### **Draft new 01 series of amendments of Regulation No. [X] concerning approval of the Full Width Rigid Barrier test**

Submitted by the expert from Japan

Model A

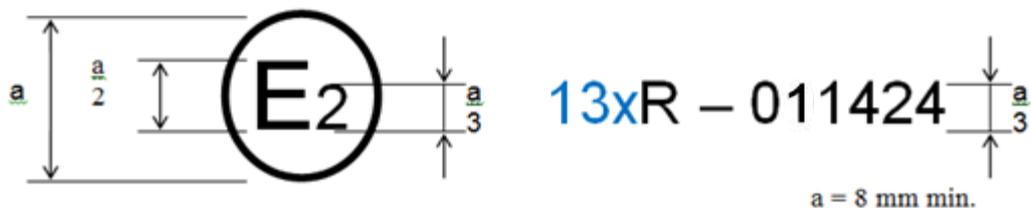
The above approval mark affixed to a vehicle shows that the vehicle type concerned has, with regard to the protection of the occupants in the event of a frontal collision, been approved in France (E2) pursuant to Regulation No. 13x under approval number 011424.

The approval number indicates that the approval was granted in accordance with the requirements of Regulation No. 13x as amended by the 01 series of amendments.

Model B

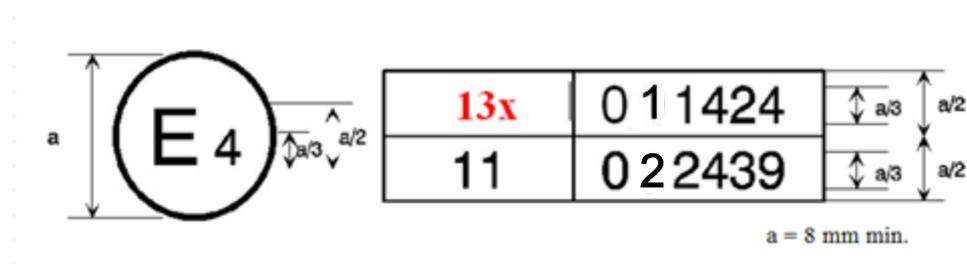
The above approval mark affixed to a vehicle shows that the vehicle type concerned has been approved in the Netherlands (E4) pursuant to Regulation Nos. 13x and 11<sup>1</sup>. The first two digits of the approval number indicate that, at the dates when the respective approvals were granted, Regulation No. 13x incorporated the 01 series of amendments and Regulation No. 11 incorporated the 02 series of amendments."
